# Illustrated part list IPL update

130

### Description of change

Improved performance regarding unstable idle, more easy to start in cold temperatures.

## 2 & 4. Clutch

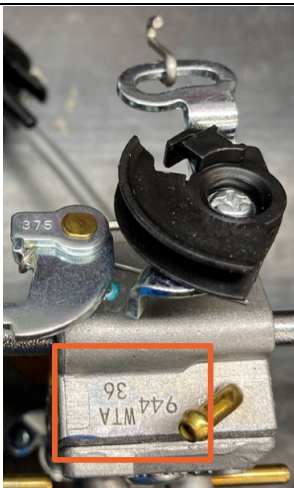
2. Clutch assy is fully interchangeable.  
Spring clutch is fully interchangeable. The Spring is a higher tension spring.  
See picture below how to define if chainsaw is equipped with new clutch (New 599 58 85-01 Spring marked with white dot).

**New part number:**

599 58 86-01 Clutch Assembly

599 58 85-01 Spring Clutch (marked with white dot)

**Old part number:**

530 01 49-49 Clutch Assembly

530 09 41-88 Spring Clutch
